FIRE SAFETY INSPECTION REPORT

Fame Apparels Ltd.

ACCORD ID: 12574

Date: 26 December, 2016

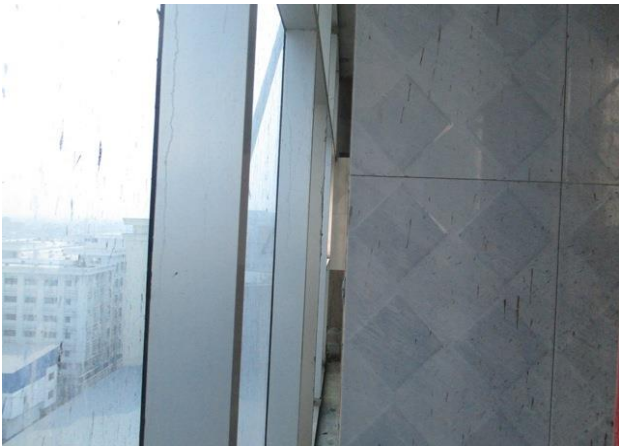
F-7	Fire Rated Construction	Penetrations through floor/ceiling assemblies are found unsealed at the north west and north east corner of the building at all floors.	Seal all penetrations and openings in floor/ceiling (full thickness of the floor/ceiling) assemblies by fire rated materials to maintain the fire resistance rating. Or Provide a minimum 2-hr fire rated shaft to separate the utility risers from each floor.	Within 2 months
-----	-------------------------	--	--	-----------------

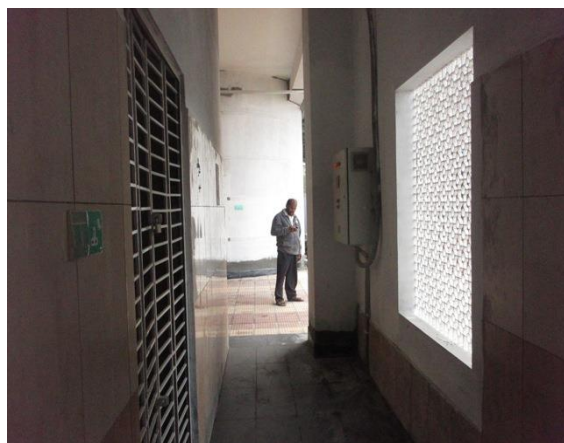
F-11	Egress	Electrical panel, Fire Alarm Panel and Storage were located in the exit stairs.	Remove all storage from exit stairs.	Within 3 months
------	--------	---	--------------------------------------	-----------------

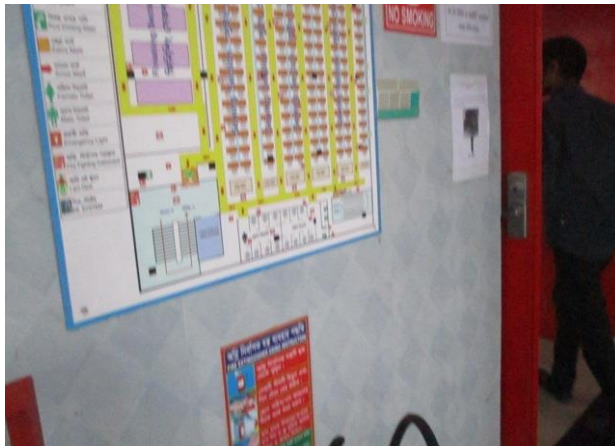
F-13	Egress	Fire evacuation maps is not posted at the entrance of all exit stair.	Fire evacuation maps shall be posted at the entrance to each exit stair.	Within 2 months
------	--------	---	--	-----------------
